# CITY OF ALBUQUERQUE

RE: **Lot 3 Block 2 Unit 27 Volcano Cliffs Subdivision  
5500 Valiente Rd. NW  
Grading and Drainage Plan  
Engineers Stamp Date; 9-15-2021 (C11D008)**

## DRAINAGE AND TRANSPORTATION INFORMATION SHEET (REV 6/2018)

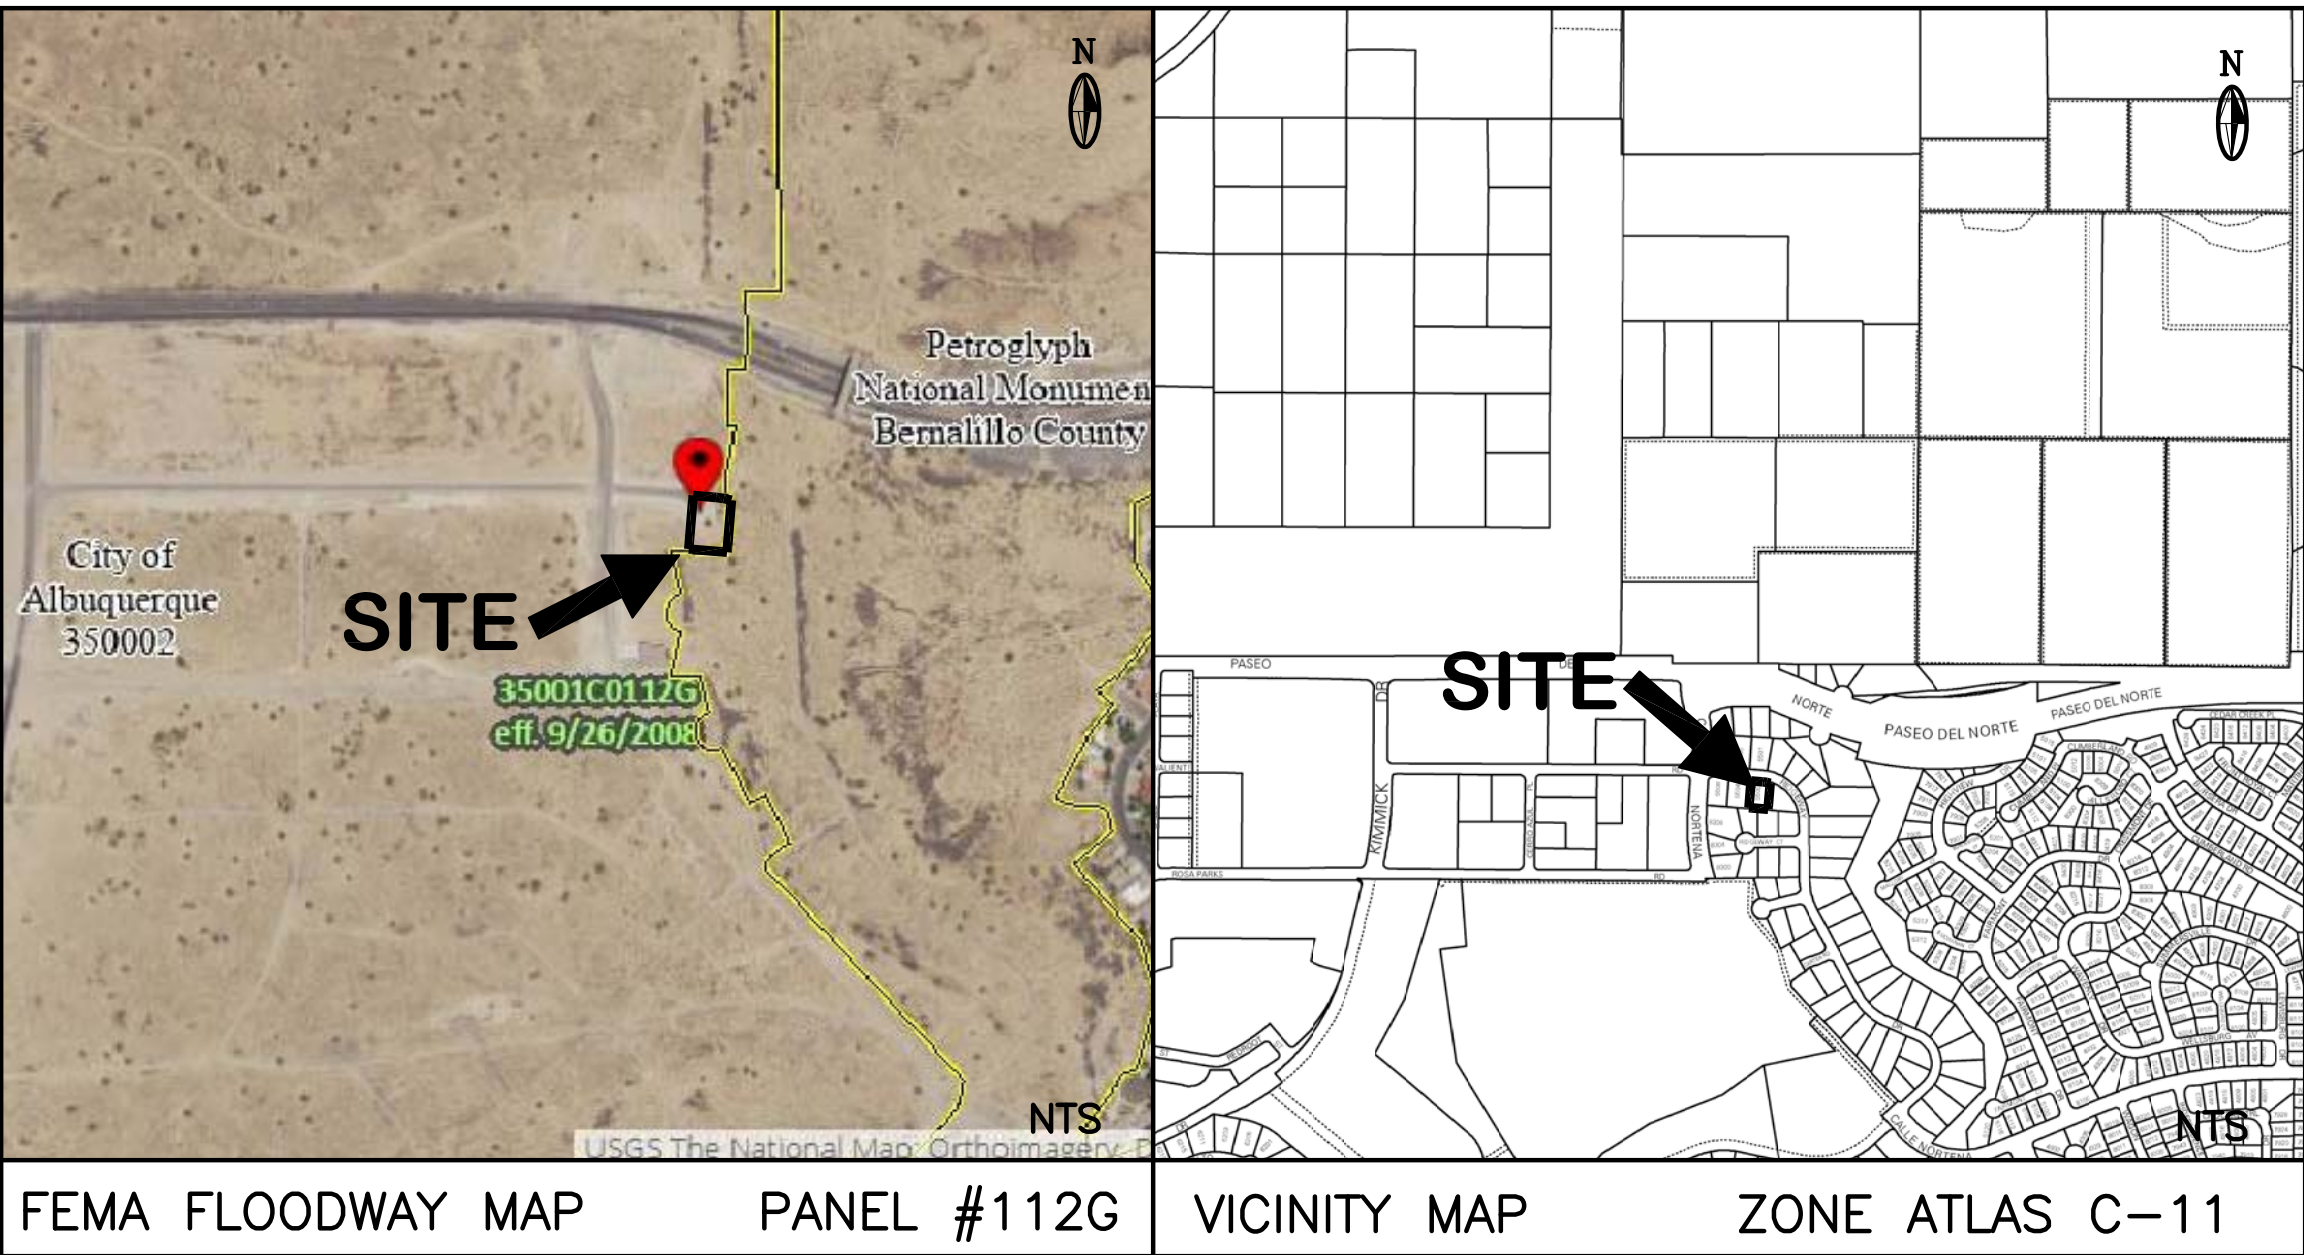
Based upon the information provided in your submittal received 9/15/2021, this plan is approved for Grading Permit.

**Reiterate to the Owner/Contractor that a separate permit for a garden/retaining wall must be obtained, with the approved G&D plan and Pad Certification. Also, let the owner/contractor know that if a pool is to be added in the future the G&D plan will need to be modified showing the location of the pool and the land treatment differences.**
